REVIEW TYPE: Preliminary Plan Review

PROJECT NAME: Montgomery Auto Sales Park

CASE #: 120041010 (1-04101)

RE: Preliminary Plan #1-04101
Montgomery Auto Sales Park

PRELIMINARY PLAN OF SUBDIVISION
MONTGOMERY AUTO SALES PARK
A RESUBDIVISION OF PART OF LOT 17, PLAT 16036 (N9723) AND LOT 18, PLAT 16036 (N9723)

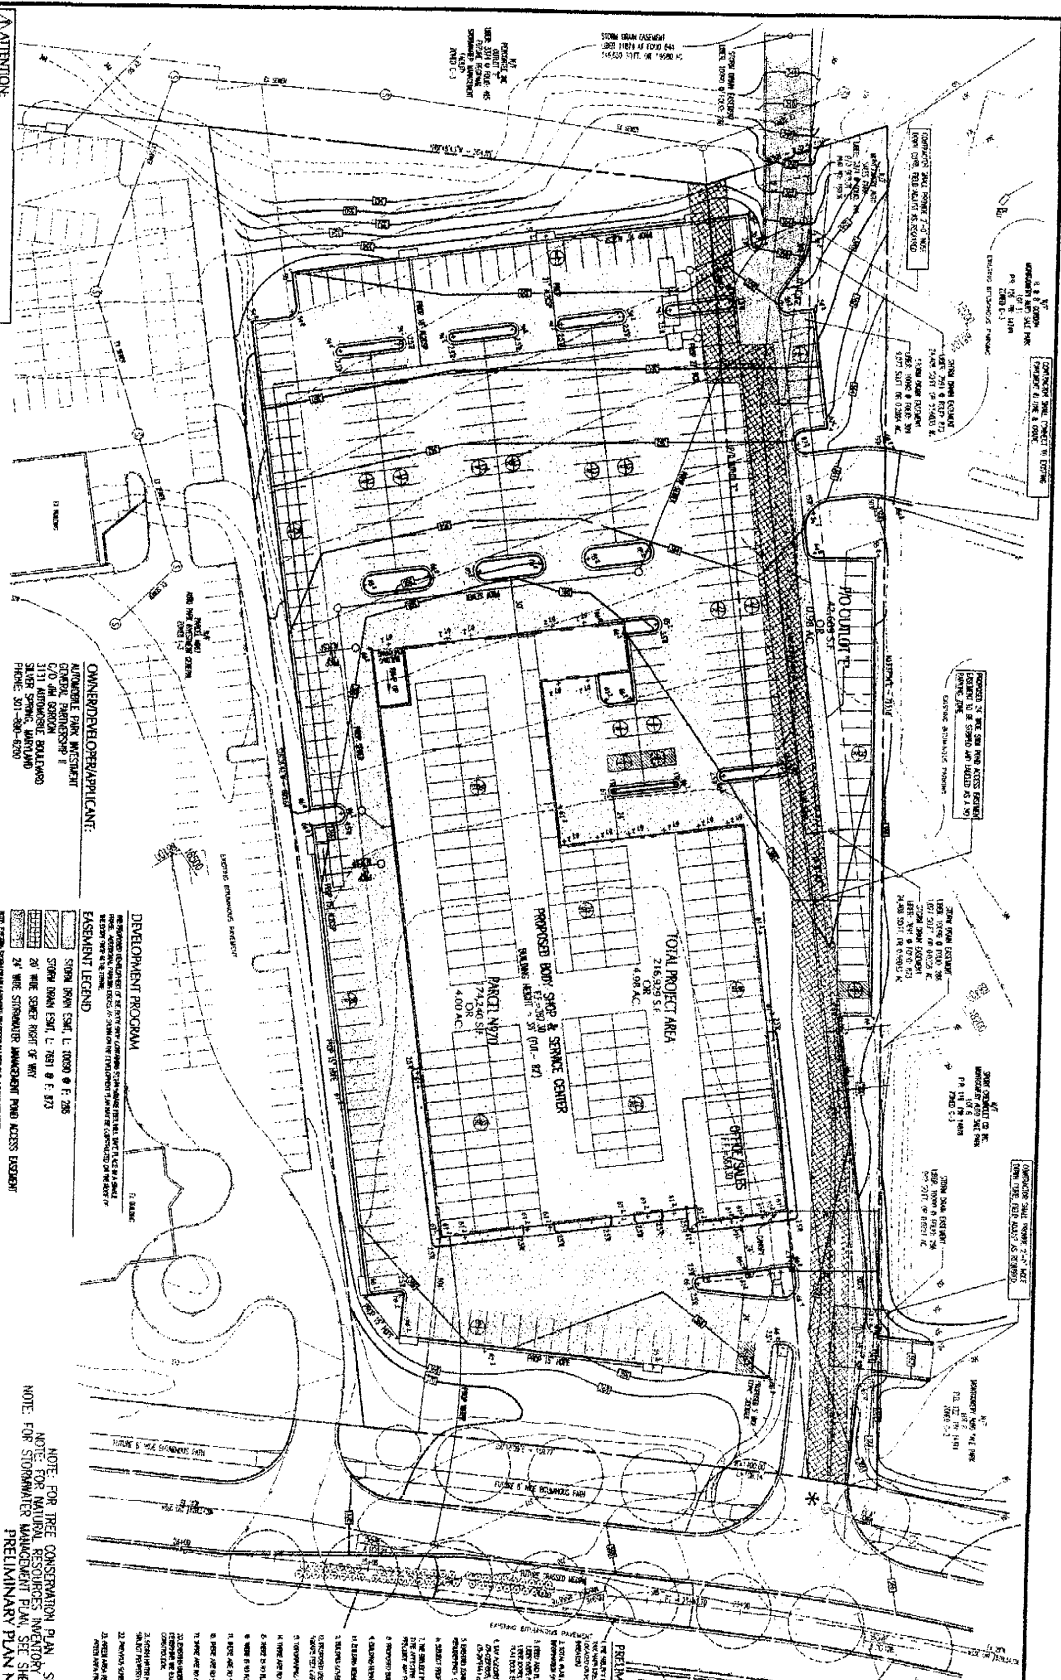
1. This plan proposes connections to an existing public storm drain system that is located on the site. Prior to submission of the record plat, the applicant will need to submit and obtain approval of their storm drain capacity and impact study. This study will need to analyze the capacity of the existing downstream public storm drain system and the impact of the post-development ten (10) year storm runoff on same.

Record plat to reflect denial of access along Briggs Chaney Road, except at the approved entrance.

3. Coordinate with the Department of Permitting Services regarding the design of the internal parking lots, truck circulation and truck loading spaces, and handicap access. The applicant may wish to contact Ms. Sarah Navid of that Department at (240) 777-6320 to discuss these issues.

5. Record plat to reflect a reciprocal ingress and egress easement to serve the lots accessed by each internal common driveway, as well as the proposed stormwater management access road.
